UNITED STATES  
NUCLEAR REGULATORY COMMISSION  
WASHINGTON, D.C. 20555-0001

May 27, 1994

FACILITY: AP600

SUBJECT: SUMMARY OF PIPING AUDIT OF THE WESTINGHOUSE AP600 DESIGN

Figure 210.9-1, sheet 1 of 2  
Typical Support Jurisdiction on CVS Module

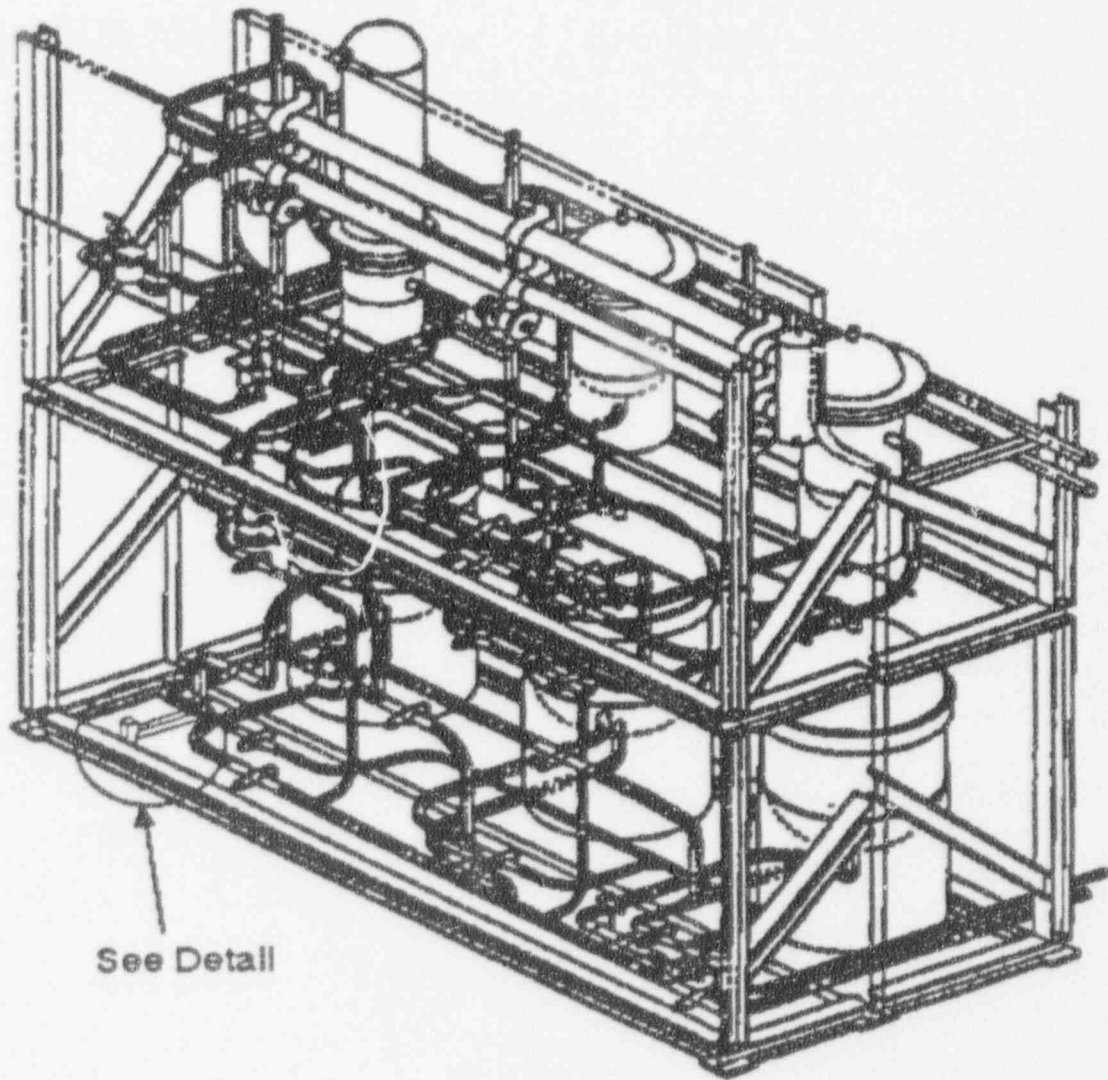
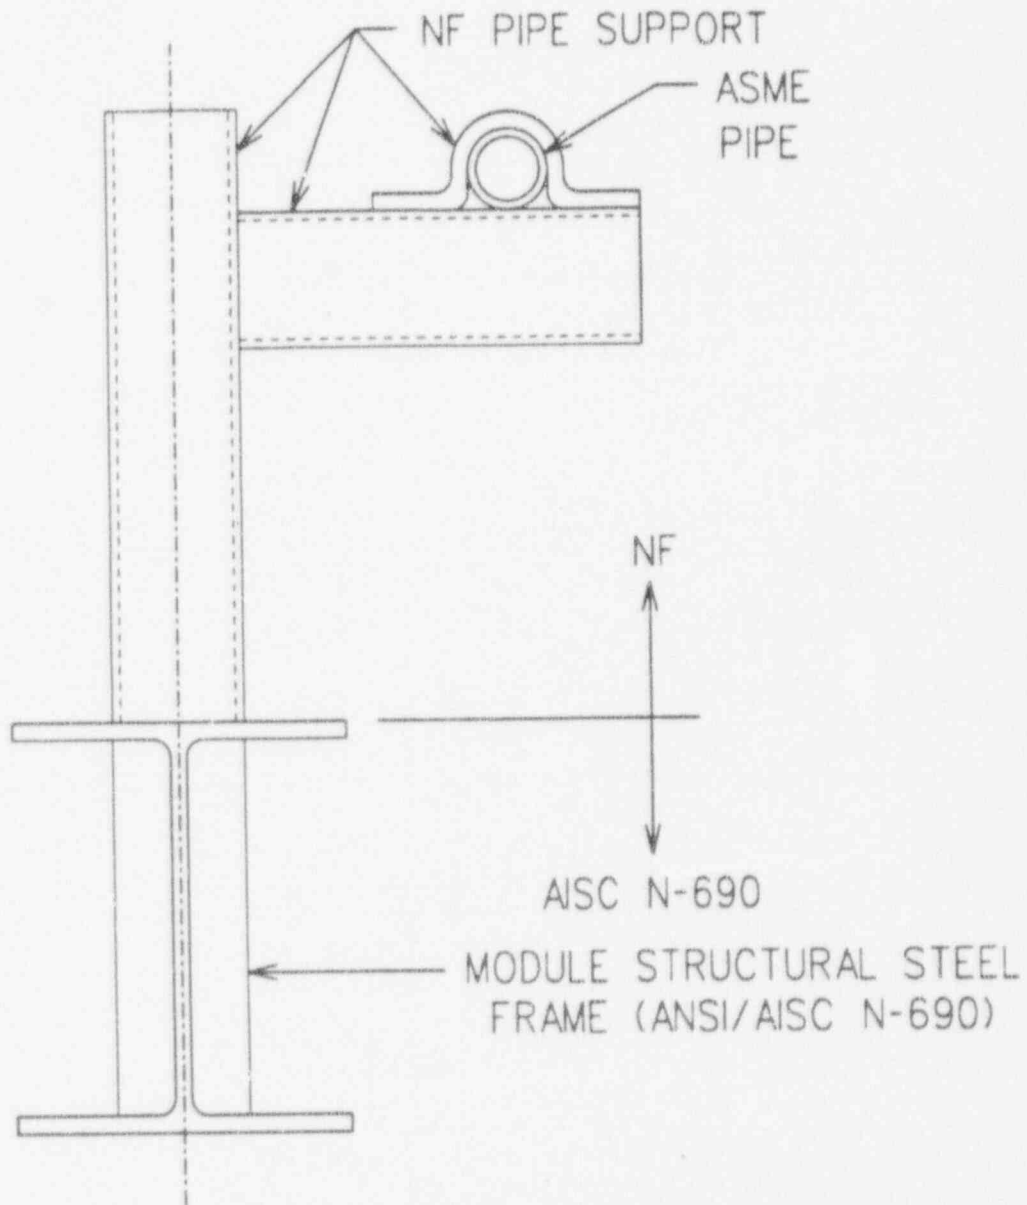
Section 3.7.3.8.3 of the SSAR, "Piping Systems on Modules," states that modules are constructed using a structural steel framework to support the equipment, pipe, and pipe supports in the module and that, with one exception, the framework is designed as part of the building structure. If, subsequent to installation of the modules, the framework is relied upon to support any portion of the piping, provide the basis for not complying with the jurisdictional boundary rules in Section NF of Section III of the ASME Code.

The ASME Code, Section III, Subsection NF, does not clearly address jurisdictional boundaries for the specific case of module structural steel framework. The module framework is considered to be a part of the building structure that is built in the shop for convenience. The module steel frame performs multiple functions (such as supporting maintenance platforms, utilities, lighting, shielding, etc.) and supports the components and piping. Figure 210.09-1 illustrates a large module and shows the NF jurisdictional boundaries. Figure 210.09-2 illustrates a smaller module and similarly shows jurisdictional boundaries. The module framework is detailed on module steel drawings, rather than on individual pipe support or component support drawings.

Modules containing safety-related equipment are classified as seismic Category I. The module steel frames are designed and constructed to ANSI/AISC N690, as described in SSAR Subsection 3.8.4. The module frame structural qualification includes the loads applied to it by the pipe and component supports, in addition to the loads exerted by the maintenance platforms, utilities, etc. Structural steel extending from the module framework to the pipe or component (or standard component support) complies with Subsection NF of the ASME Code.

The jurisdictional boundaries described in this response have been developed based on the 1992 Code. ASME Code committees are currently considering revisions to the Code that would permit the use of AISC N690 for linear support structural steel. If this change is adopted by ASME and endorsed by the NRC, the linear supports would change from NF to AISC N690, thus making them the same as the module structure.
